Re: *Addendum No. 1*
Pierce Drive Stormwater Improvements
ABC Water & Stormwater District

Date: June 18, 2025

PIERCE DRIVE STORMWATER IMPROVEMENTS
MAHONING COUNTY BOARDMAN, OHIO
BASE BID - PROPOSED STM REPLACEMENT (1 OF 3)

PROJECT NO:	242260
DRAWING NAME	C-11
SHEET	OF
14	15

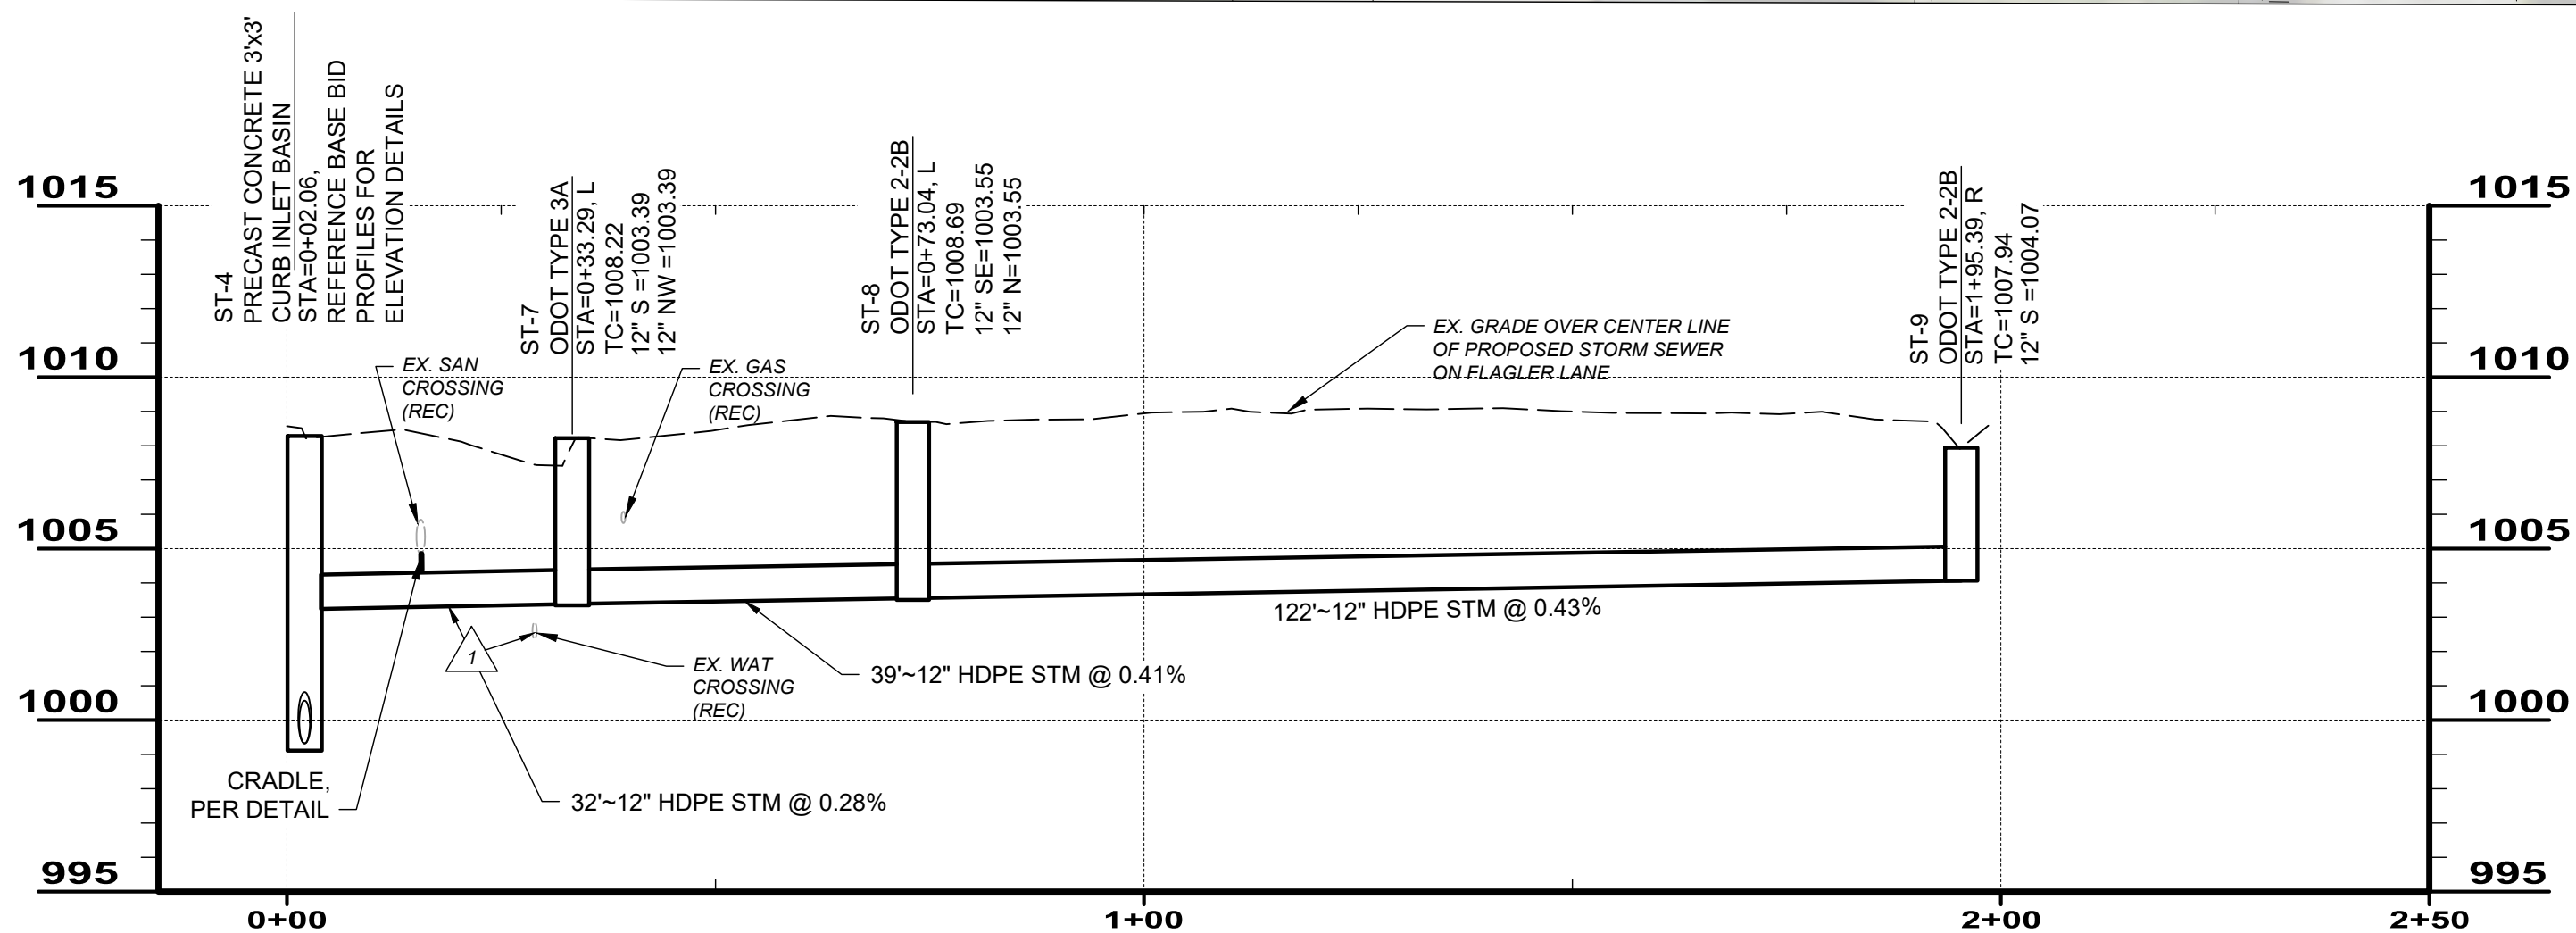
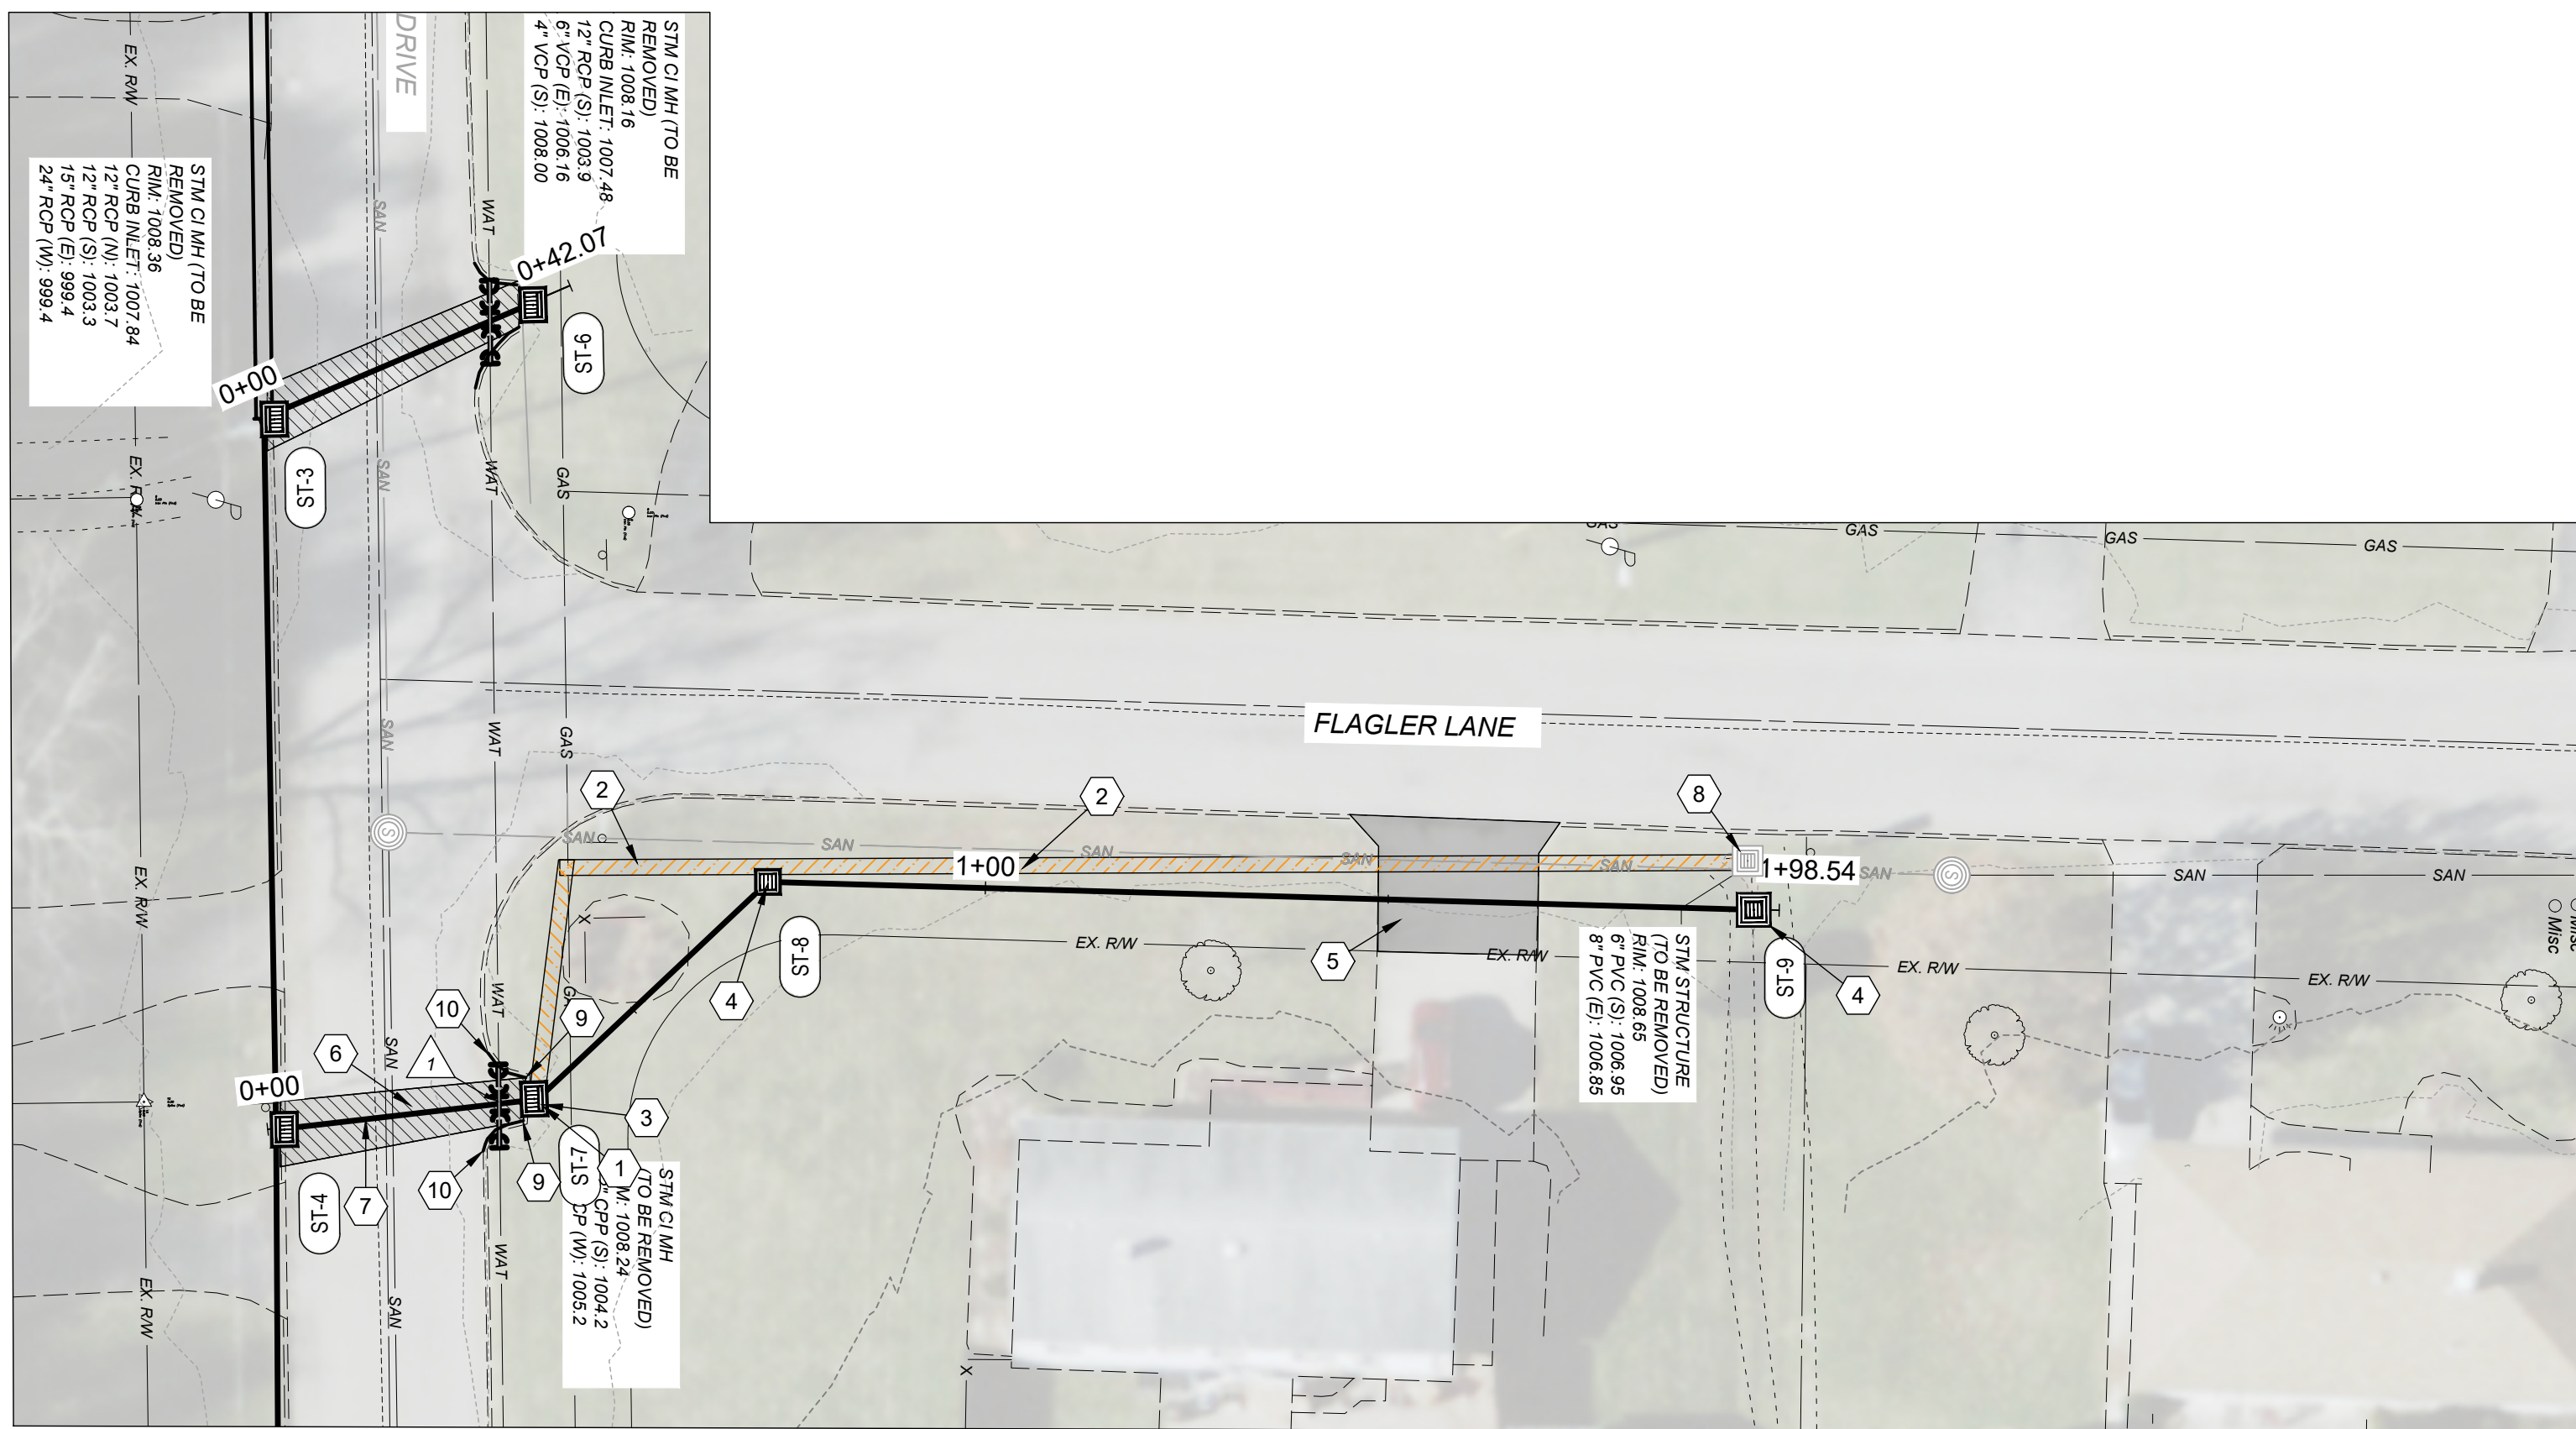
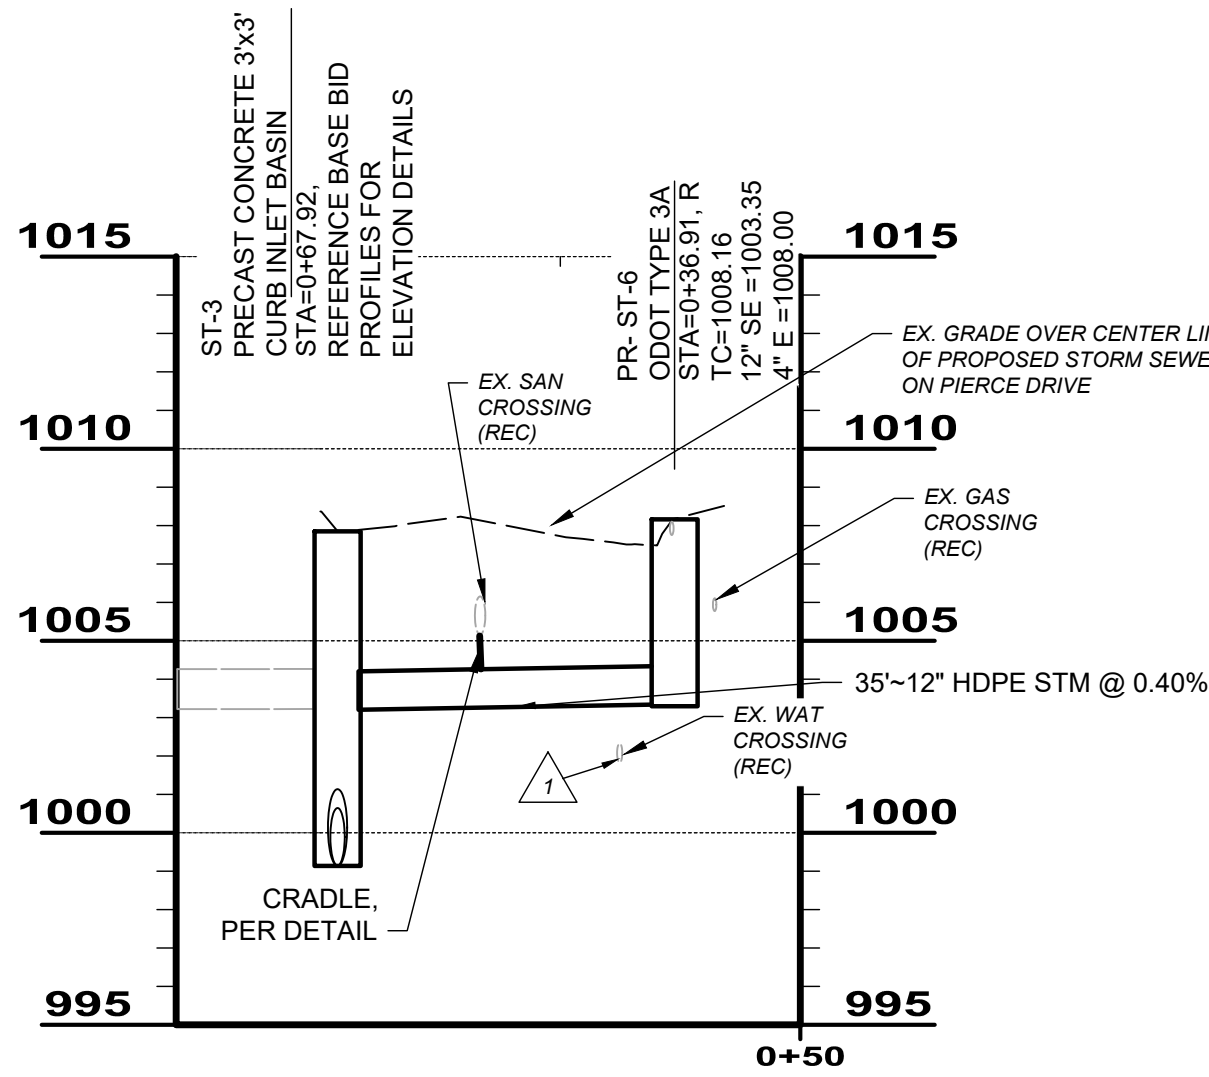
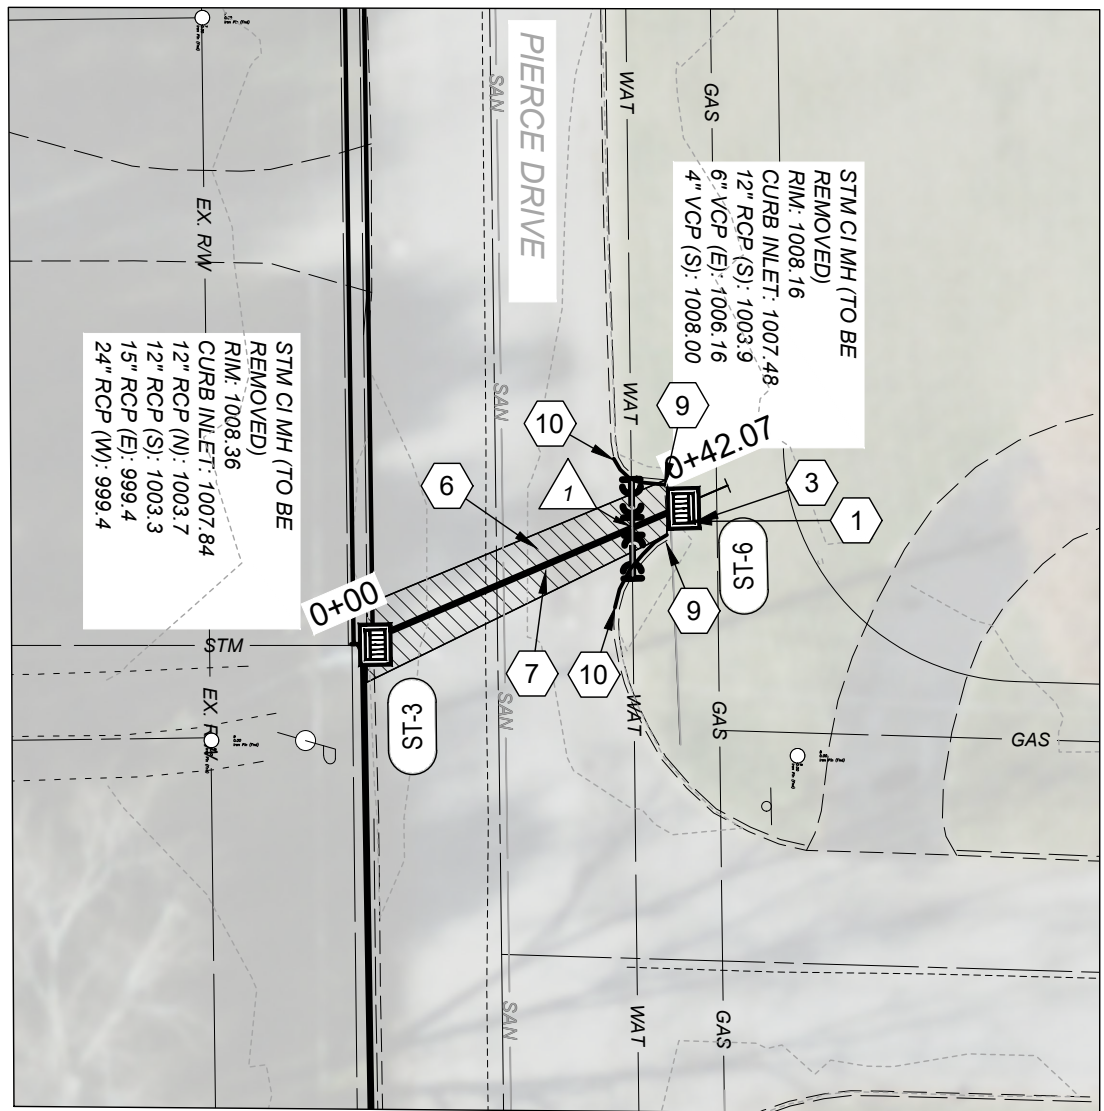
Replace plan sheets 9, 10, 11 and 14 with the enclosed Revised plan sheets 9, 10, 11 and 14.

NO	REVISION	DATE
1	SHEET EDITS - ADDENDUM 1	6/18/25

- THE CONTRACTOR SHALL SUPPORT THE EXISTING WATERLINE DURING THE STORM SEWER INSTALLATION. A BID ITEM HAS BEEN ADDED TO THE BID PROPOSAL IN THE EVENT THE WATERLINE HAS TO BE LOWERED TO MAINTAIN 18" MINIMUM VERTICAL SEPARATION FROM THE SEWER. USE 45' LONG SWEEPING BENDS, PLACE NEW 6" DIP WATER LINE W/ POLYWRAP INSIDE 12" DIAMETER STEEL CASING WITH SPACERS AND MAKE NEW WATER PIPE CONNECTION TO THE EXISTING LINE WITH A YOUNGSTOWN WATER DEPARTMENT APPROVED PIPE COUPLING. IF THE WATERLINE LOWERING IS NOT REQUIRED, IT SHALL NOT BE PERFORMED. CITY OF YOUNGSTOWN MUST BE ON THE SITE TO COORDINATE WITH HOMEOWNERS. FLUSH, SAMPLE THE SYSTEM, AND PLACE USERS UNDER A BOIL ADVISORY.
